## DECLARATION STATEMENT - RECORD OF DECISION

Xerox Webster Landfill Site  
Town of Webster, Monroe County, New York  
Site Registry No. 8-28-013  
Classification Code: 2

### Statement of Purpose:

FIGURE 3

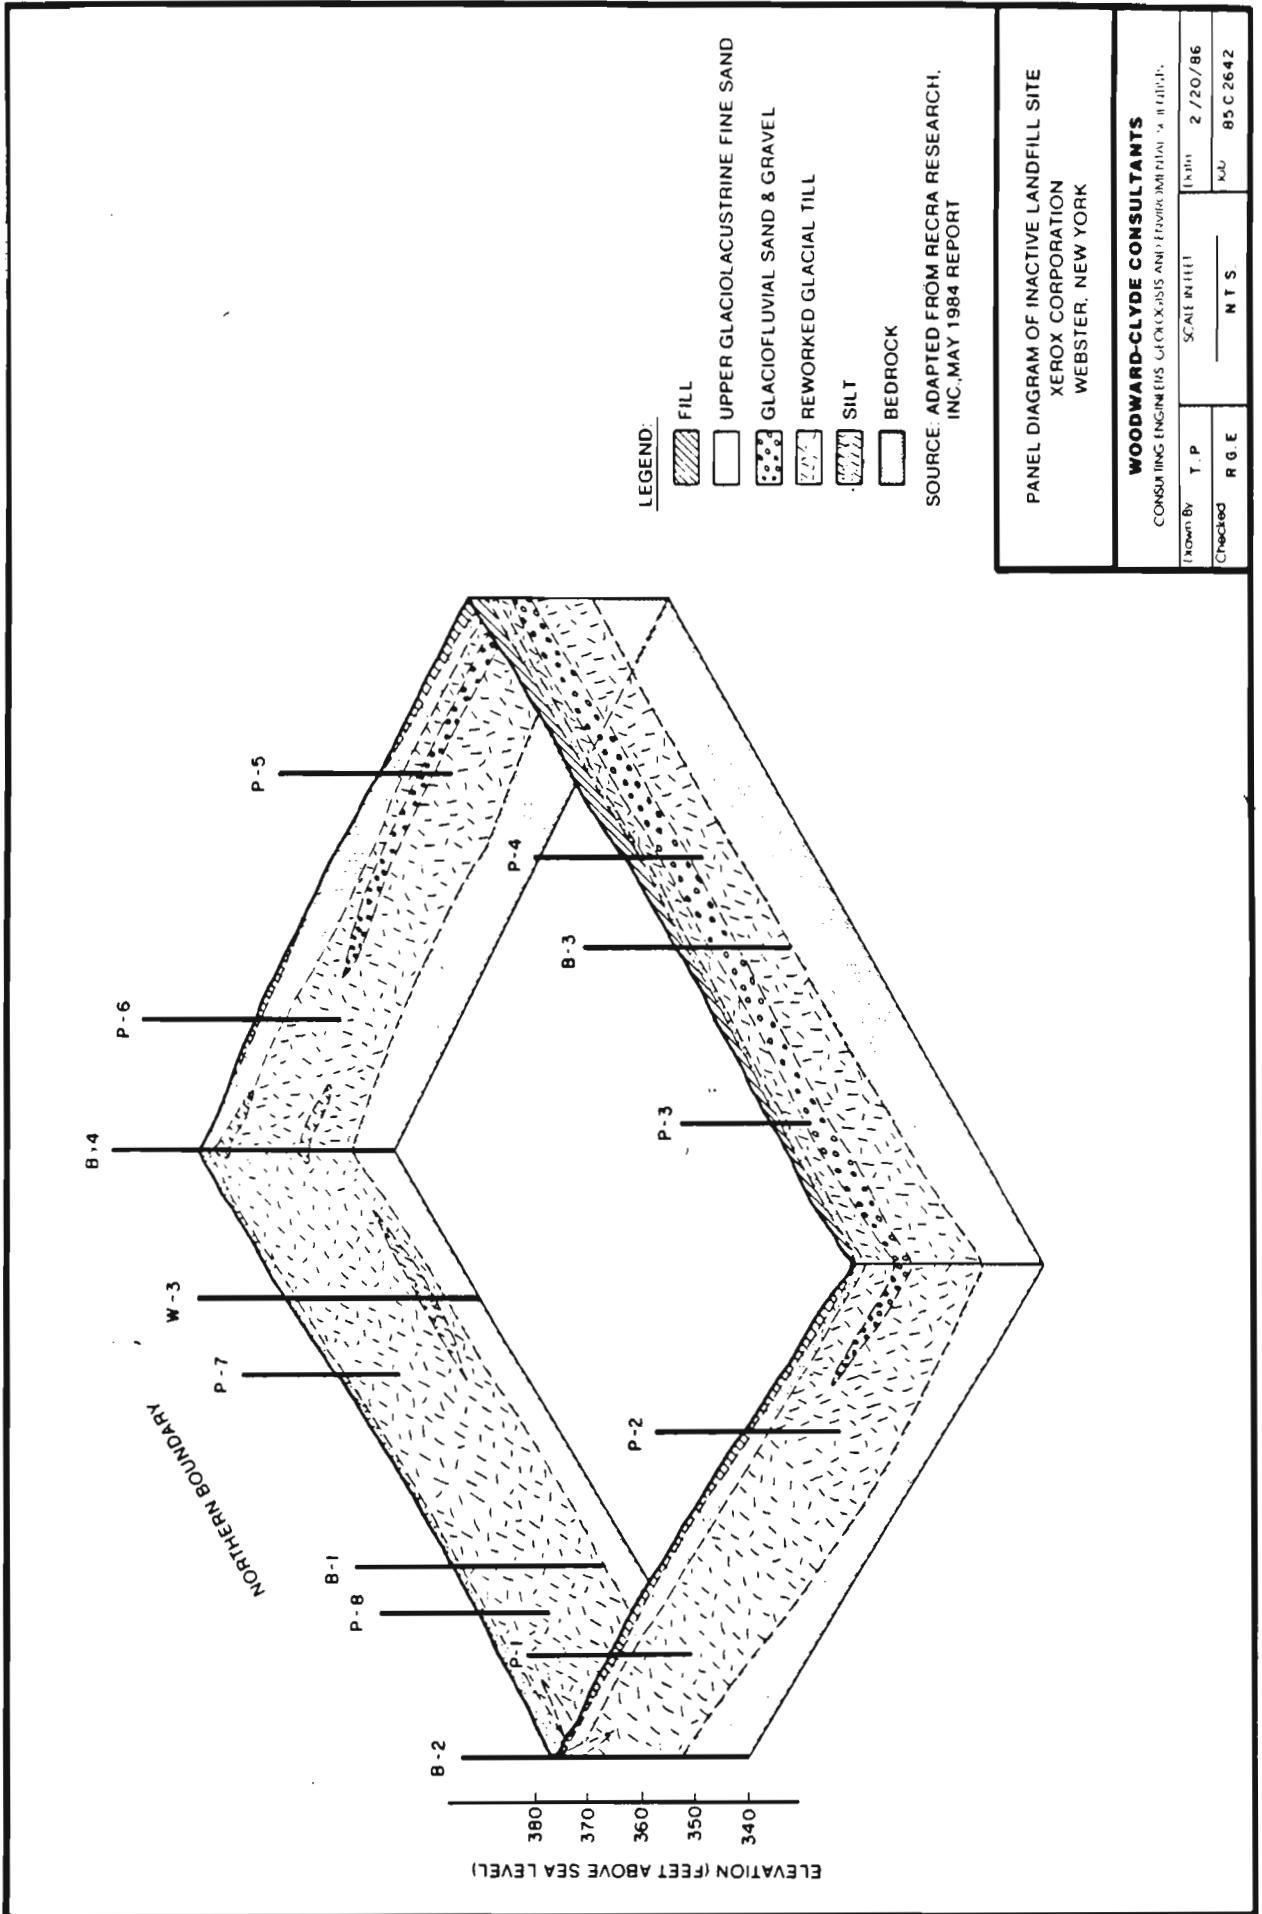
4. Monitoring Well B-17 is downgradient of the landfill and has been shown to be contaminated, yet Figure 3 does not indicate that groundwater at that location will be captured by the selected remedial plan. This situation needs to be specifically addressed in the Addendum.
